STAFF RECOMMENDATION
2020 10th Avenue South
May 16, 2018

Application: New construction—infill; Setback determination
District: Waverly-Belmont Neighborhood Conservation Zoning Overlay
Council District: 17
Map and Parcel Number: 10509041200
Applicant: William Smallman
Project Lead: Melissa Sajid, melissa.sajid@nashville.gov

Description of Project: Application is to construct infill on a vacant lot. The request includes a setback determination to reduce the left side setback along Benton Avenue from ten feet (10') to approximately seven feet, eight inches (7'-8").

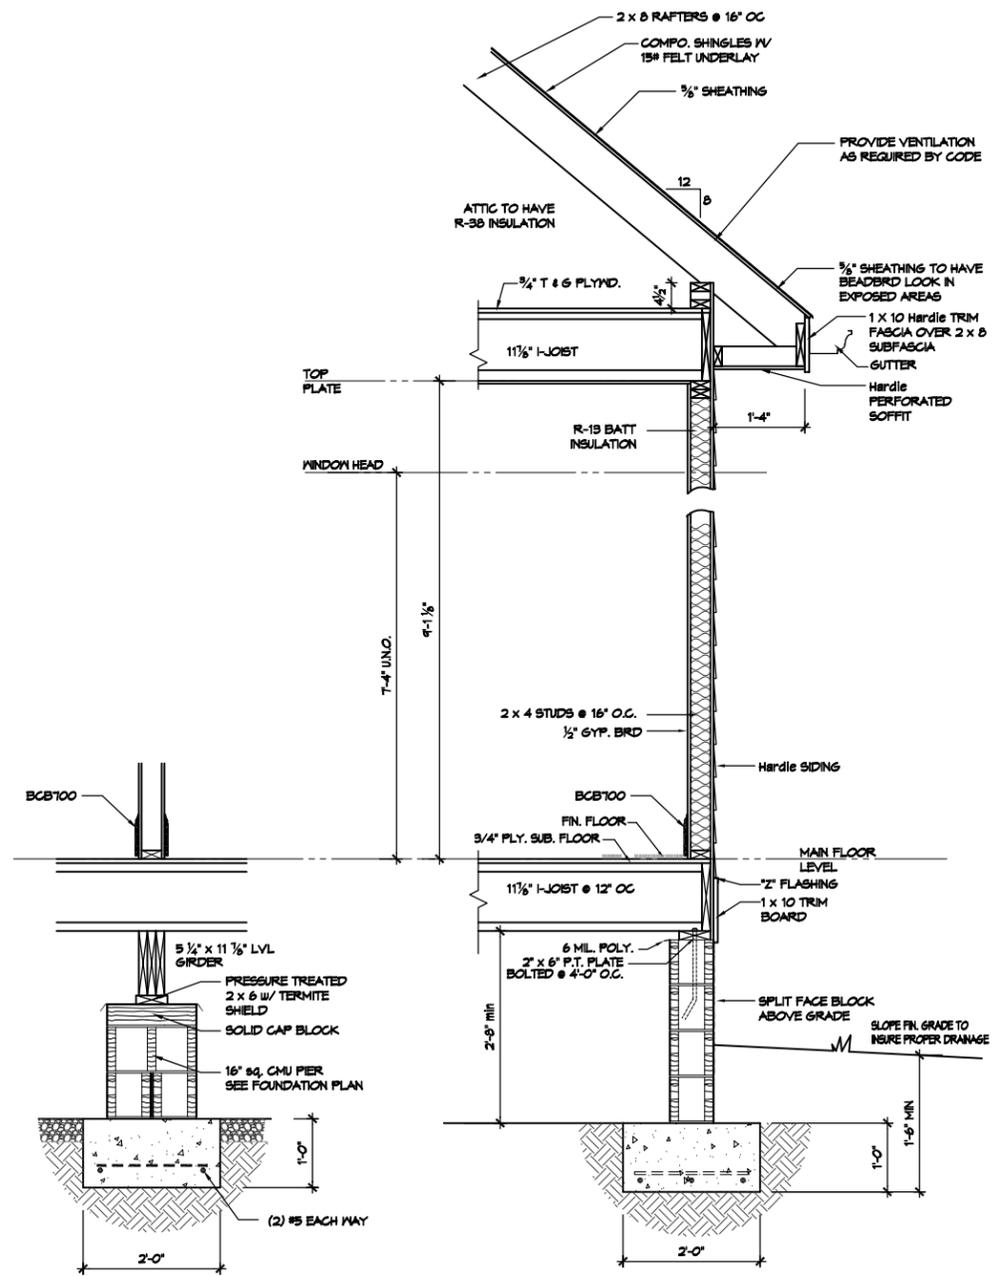
Setback & Rhythm of Spacing: The proposed infill meets all base zoning setbacks except for the left side setback, which should be at least ten feet (10') to meet bulk zoning standards and to not encroach in the public utility and drainage easement. The infill will be situated fifty-three feet (53') from the front property line, which is similar to front setback of the historic house next door at 2020 10th Avenue South. The right side setback will be five feet (5'), and the rear setback will be seventy-five feet (75').

The applicant has requested a left side setback determination to reduce the setback along Benton Avenue from ten feet (10') to approximately seven feet, eight inches (7'-8"). Staff finds the reduced left side setback to be inappropriate for several reasons. At approximately forty-six feet (46') wide, the lot is already narrower than other lots with

historic homes along 10th Avenue South. The narrowness of the lot creates a challenge to maintain a rhythm and spacing that is consistent with historic buildings along 10th Avenue South. Staff has advised the applicant that a narrower house would be more appropriate for this narrow lot and that the building width should be reduced so that the infill meets both side setbacks. Furthermore, a ten foot (10') wide public utility and drainage easement exists along the Benton Avenue frontage, and any reduction of the setback along this frontage would result in the infill encroaching into the easement. Water Services has indicated that no structure can be built within the easement.

Staff finds that the requested left side setback determination to be inappropriate and further finds that the infill's setback and rhythm of spacing do not meet Section III.C. of the design guidelines.

sheet title
Elevations

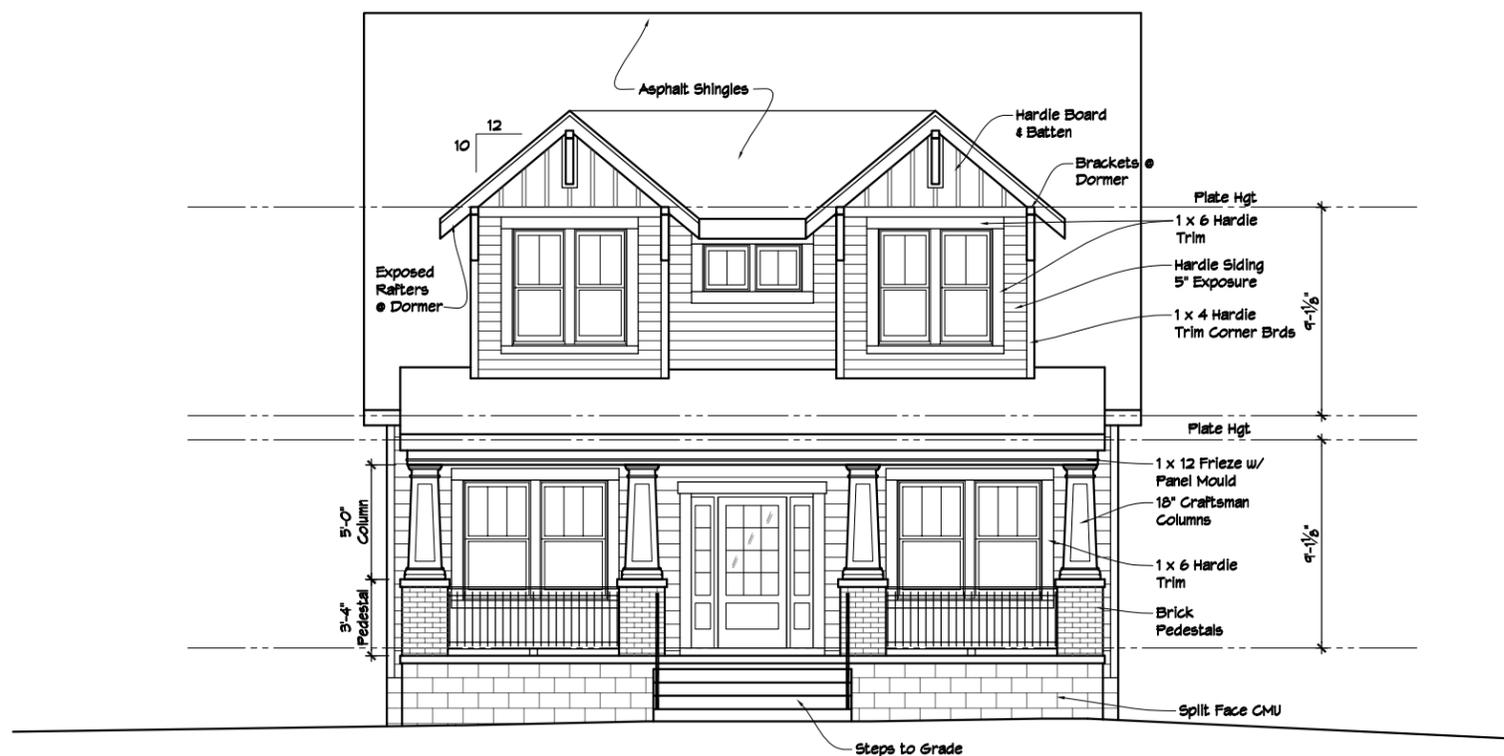
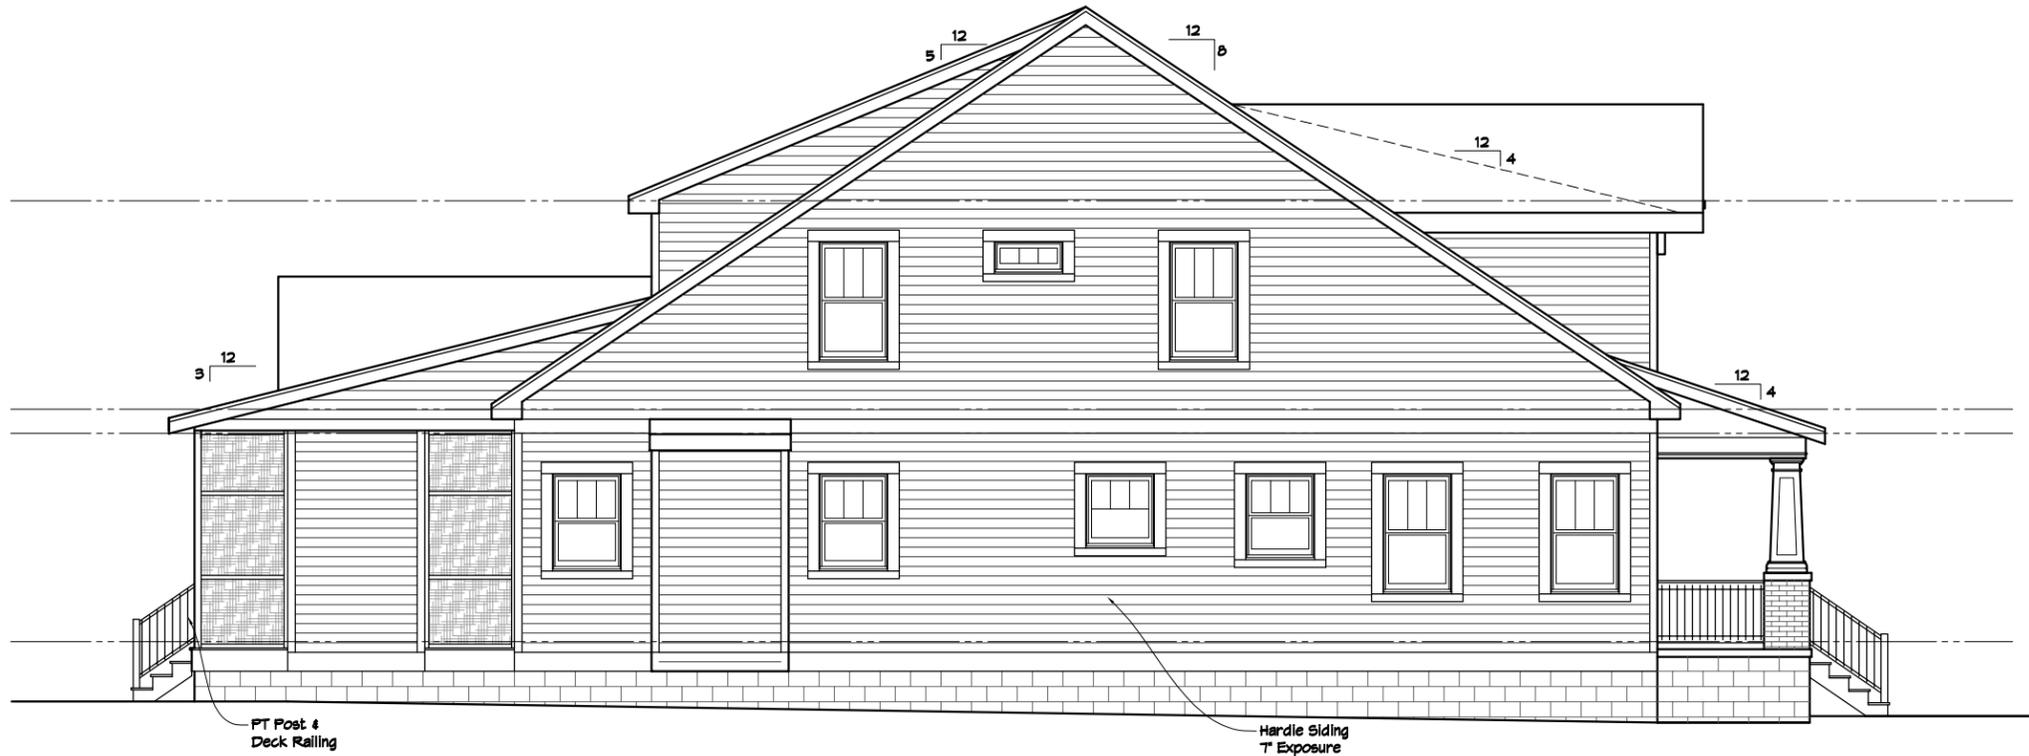
Height & Scale: The proposed house is one-and-a-half stories, with a maximum height of thirty-one feet (31') from grade. To determine the historic context, staff typically looks to the block-face, but in this case, the houses on the opposite side of 10th Avenue South do not orient to that street. Therefore, staff looked at historic houses oriented to 10th Avenue South between Benton Avenue and South Douglas Avenue. Within that

area, there are three one-story historic houses and one historic house that is one and a half stories. The height range of these historic homes is twenty-one feet to twenty-eight feet (21' – 28'). The historic house next door to the infill is single-story with an overall height of approximately twenty-one feet (21'), which is ten feet (10') shorter than the proposed infill.

As proposed, the infill would be between three feet (3') and ten feet (10') taller than the historic homes in the immediate area. Furthermore, the narrowness of the lot and location at the corner will exacerbate the height and scale of the infill. A new building that is both narrower and taller than the historic context will not meet the historic context.

Proportion and Rhythm of Openings: Not all of the windows on the infill are generally twice as tall as they are wide, thereby meeting the historic proportions of openings. The side façades include a number of horizontal windows that will likely be visible. There is also a twenty-six foot (26’) expanse of wall space on the first-level of the right side façade that does not include a window or door opening. The design guidelines state that “in most cases, every 8-13 horizontal feet of flat wall surface should have an opening (window or door) of at least 4 square feet”. The applicant has indicated that he is willing to work with staff so that the project meets the design guidelines for the rhythm and proportion of openings; however, staff’s concerns about the height and scale of the infill would cannot be addressed via conditions of approval as a redesign of the project would be needed. Therefore, staff finds the project’s proportion and rhythm of openings does not meet Section III.G. of the design guidelines.

Based on the historic context, a compatible infill would likely have a maximum width of approximately twenty-eight feet (28'), and the overall height should be similar to the historic house next door at 2020 10th Avenue South. This may be a case where a single-story infill may be more appropriate than a one and one-half story infill. Staff finds that the overall height and scale of the proposed infill exceed that of the historic context and that the narrowness of the lot and location at the corner will likely magnify the scale of the infill. For these reasons, staff finds that the proposed infill does not meet Sections III.A and B. of the design guidelines.
